# Bradley Heights Apartments

## A 236-Unit Apartment Development Puyallup, Washington

### Bradley Heights SS LLC

**BUILDING E** SIDE ELEVATION

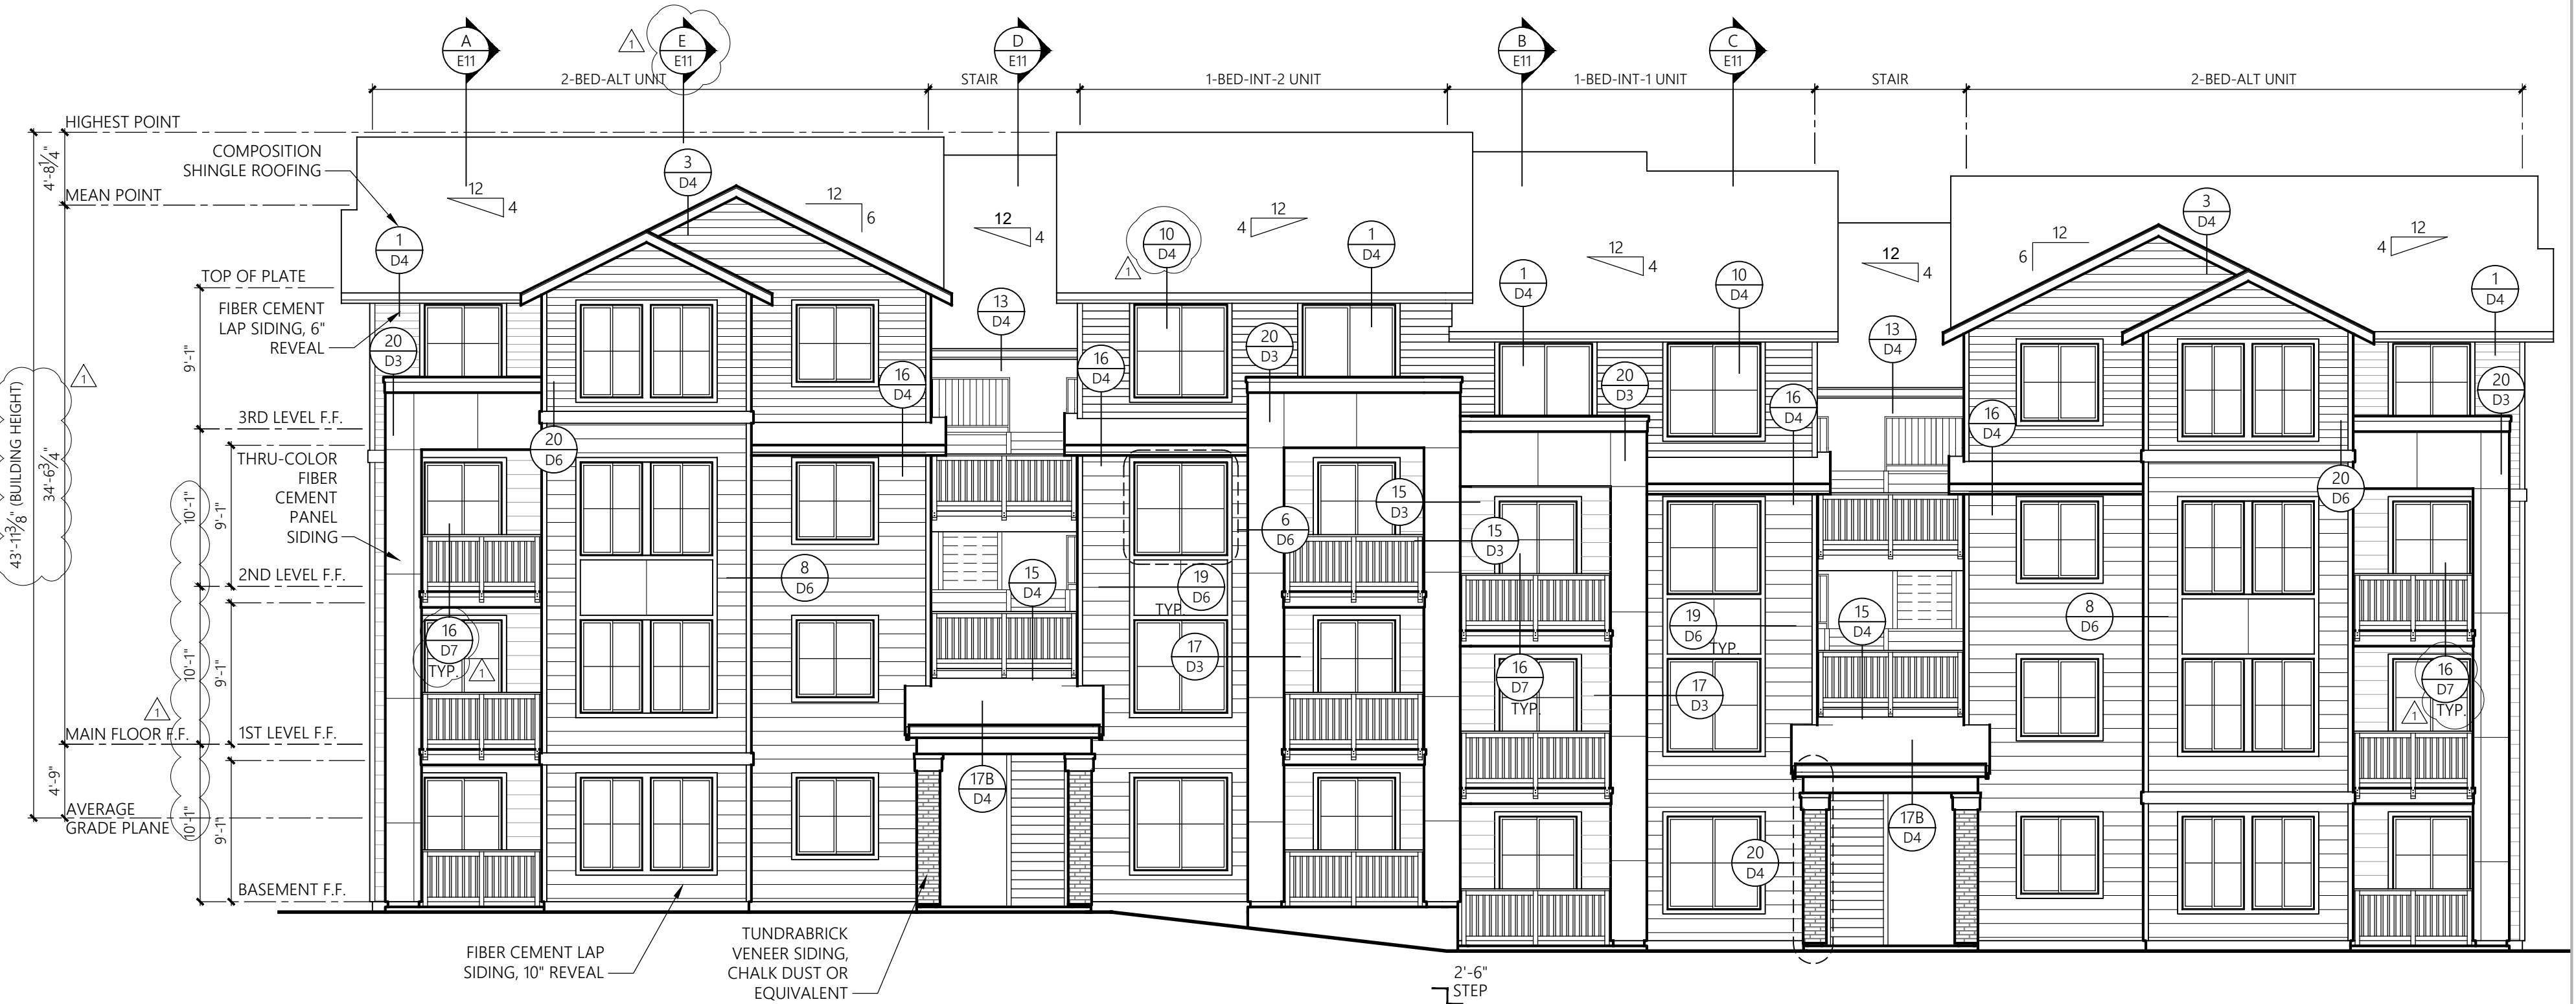
Detail and show draftstops in attic as needed per Washington State Building Code, 708.4.2. Update the attic ventilation as needed based upon changes for draftstops.  
(Construction Set, Sheet R5, Unit Plans)

**18** SPACED DECKING TO WALL  
3" = 1'-0"

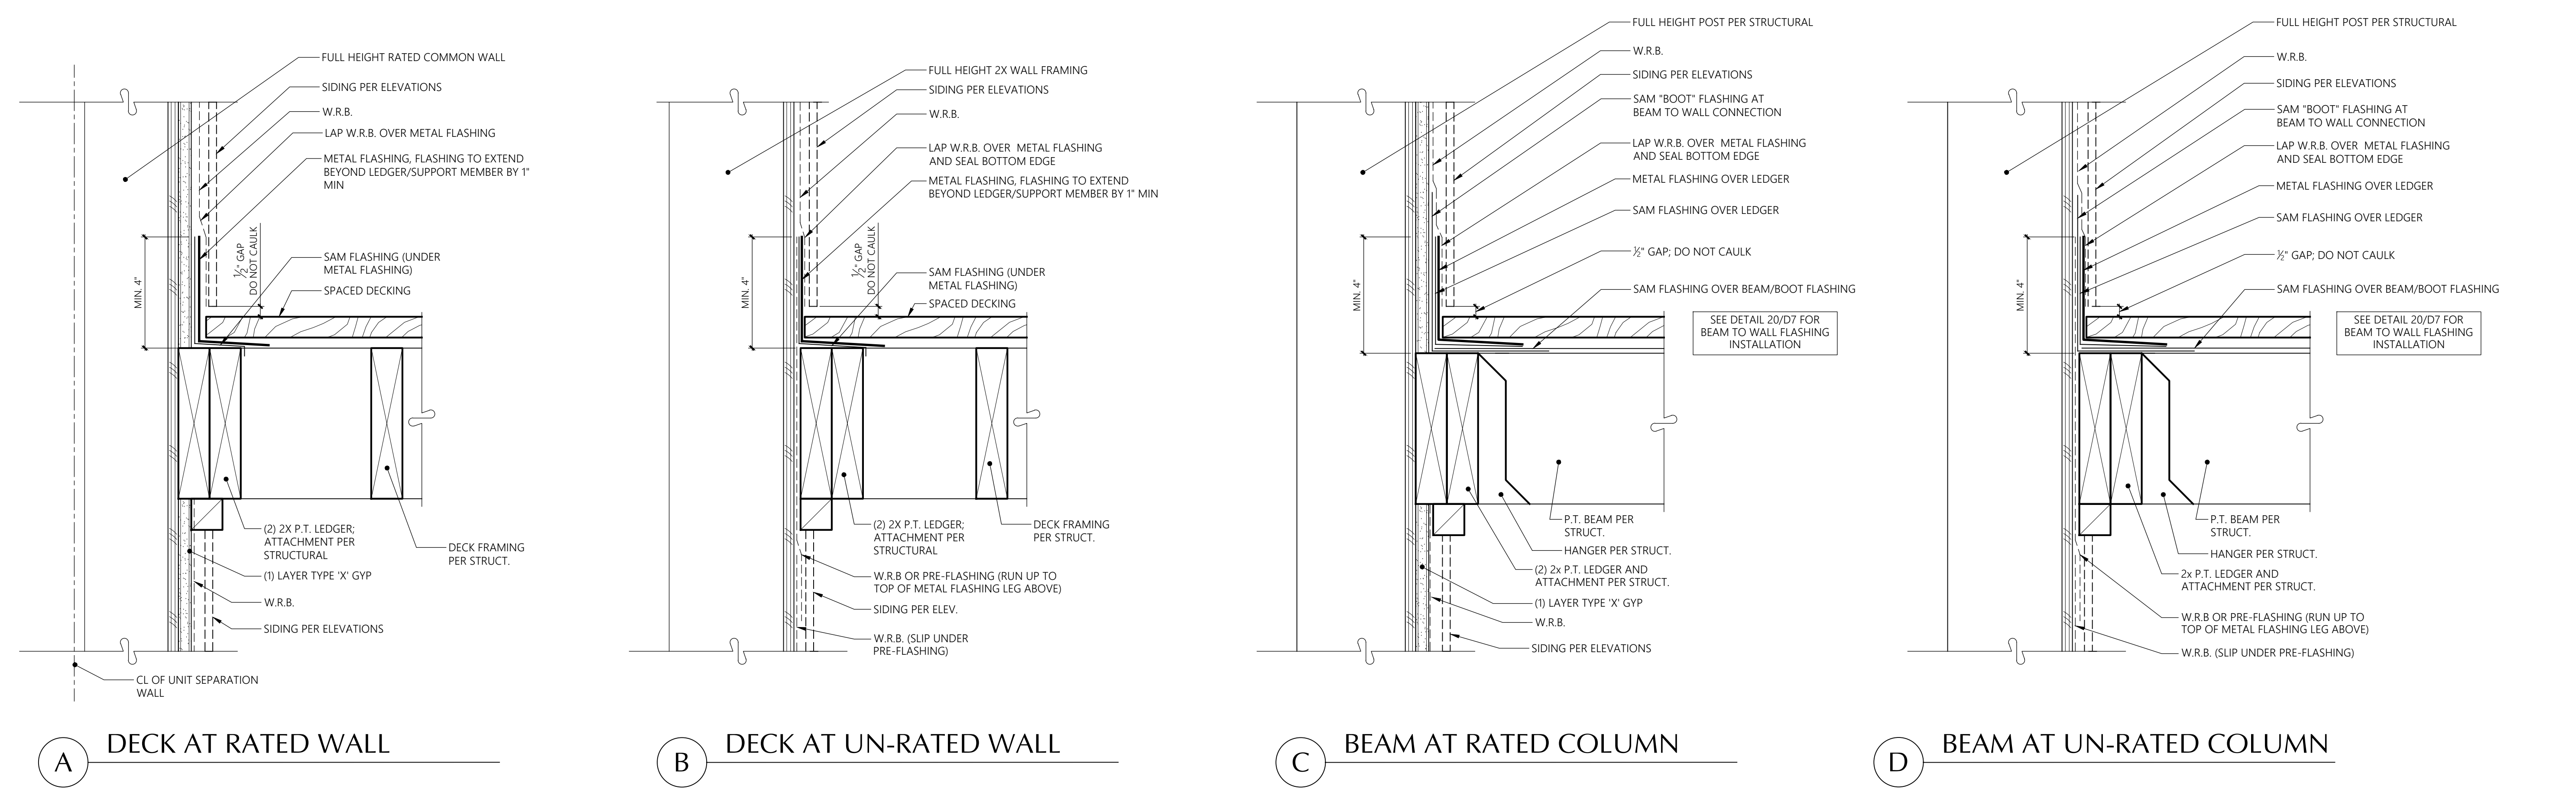
Detail 1 for the Furred Ceiling at 1-hr wall appears to have sheathing being used to create a positive connection between the metal framing that is attached to the ceiling and metal framing at the bottom of the soffit. Identify the minimum sheathing material needed, also identify minimum faster for field and edge of sheathing. Identify minimum metal framing requirements to include type, minimum fasteners for positive connection.  
(Construction Set, Sheet D8, Detail 1)

11 OUTSIDE CORNER  
NO SCALE

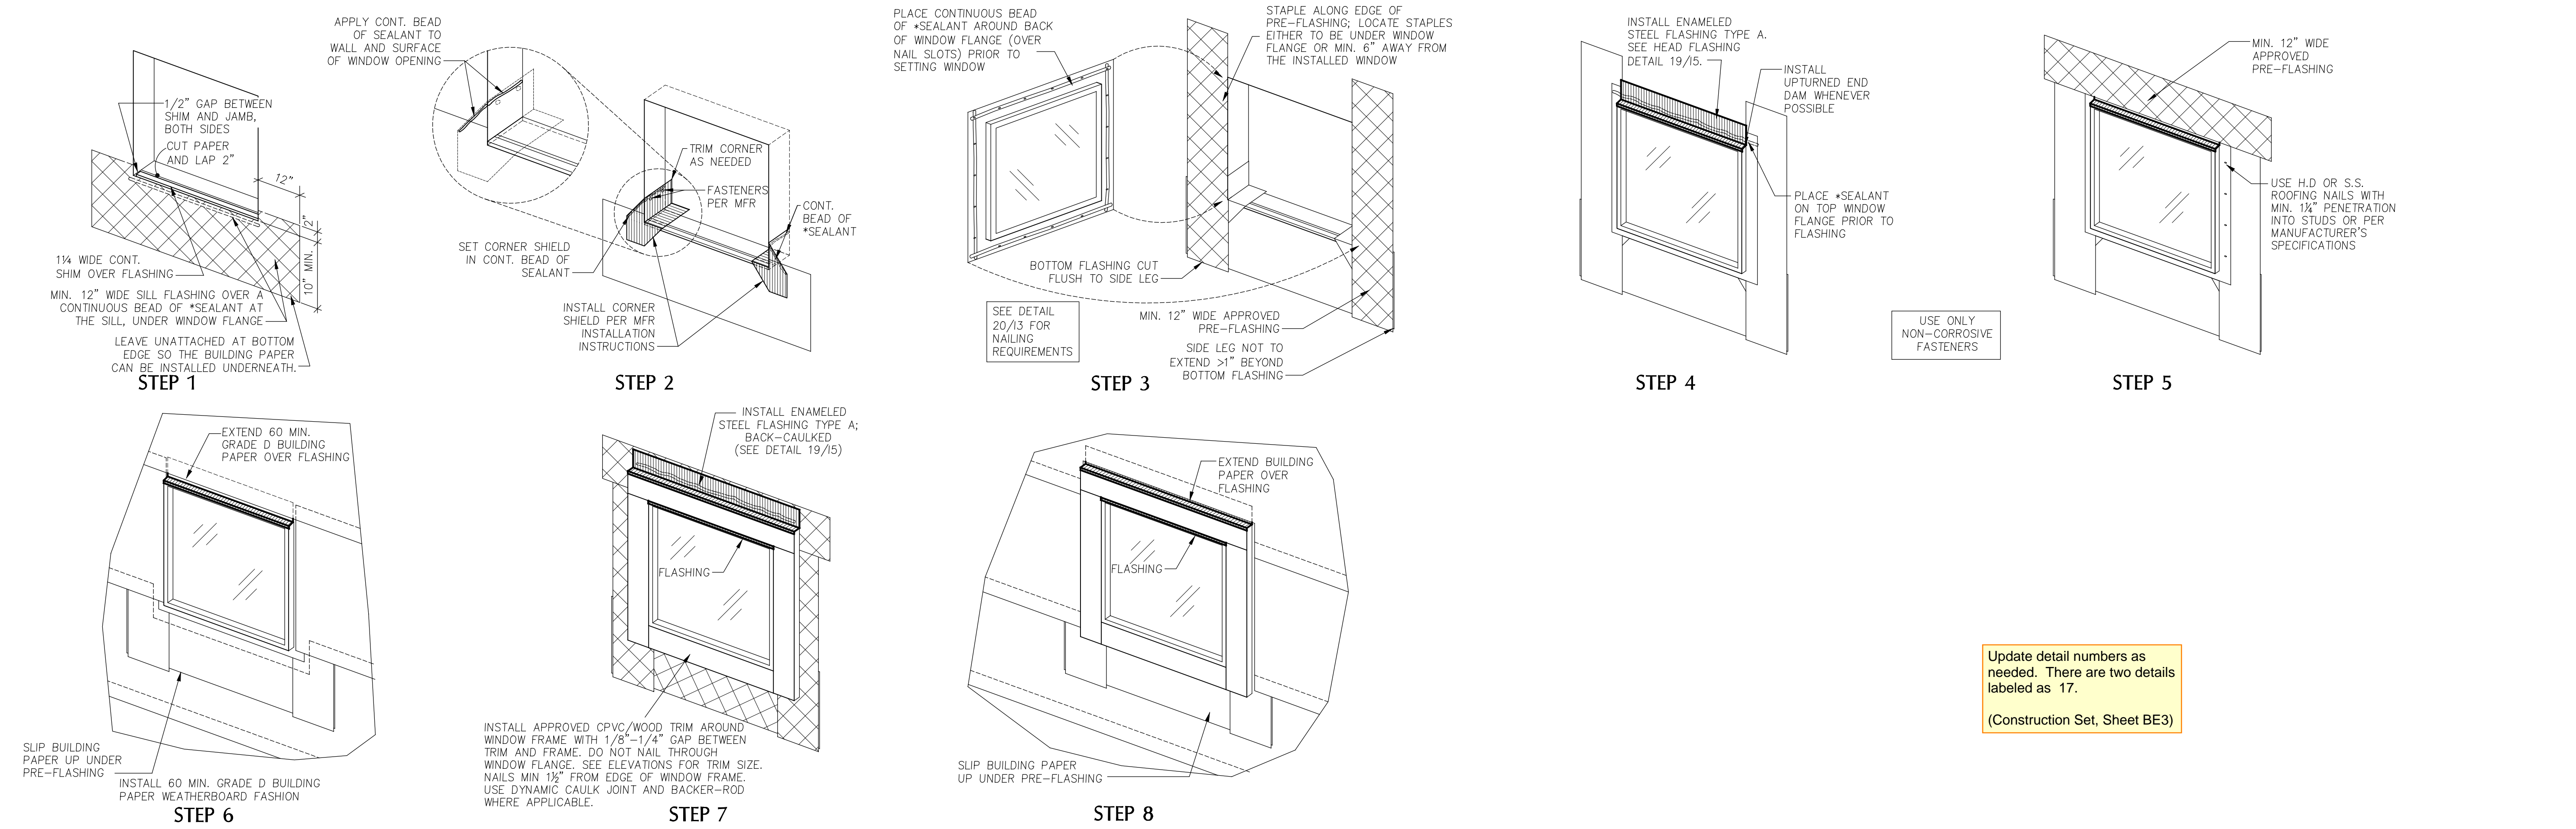
Update detail numbers as needed. There are two details labeled as 17.  
(Construction Set, Sheet BE3)

BUILDING E  
1st LEVEL PLAN  
1/8" = 1'-0"  
3/4 SPLIT LEVEL, 28-UNIT BUILDING

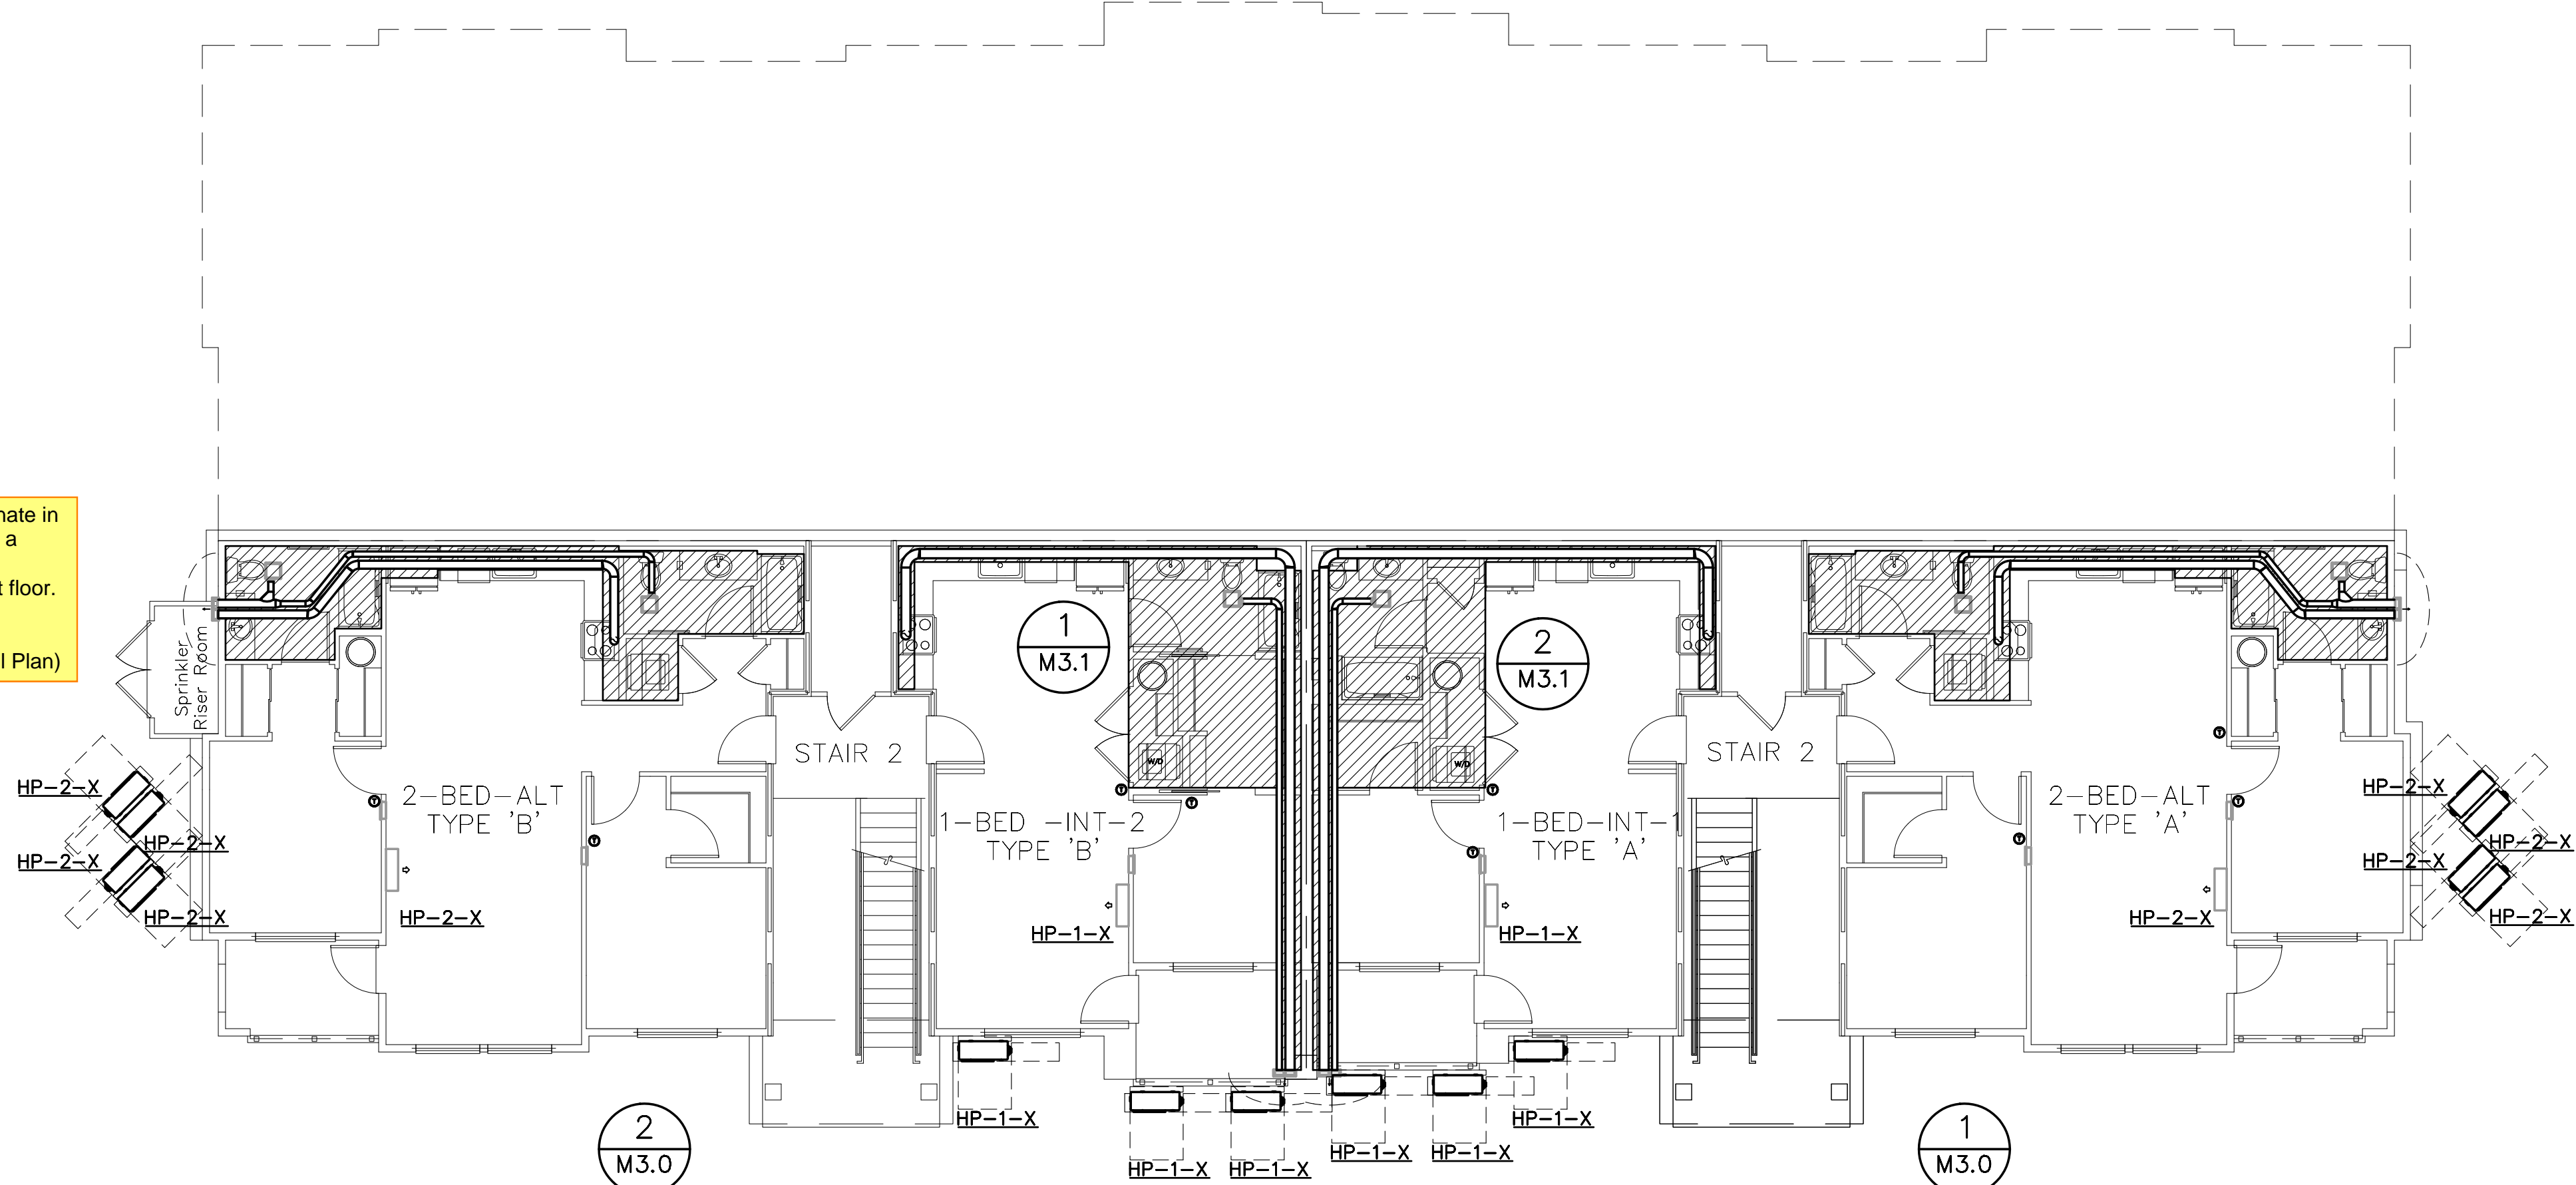
Duct runs for range hoods on interior units appear to be about 63 feet. Provide specifications on range hood that will accommodate a long run.  
(Construction Set, Sheet M2, M3 and M3.1)
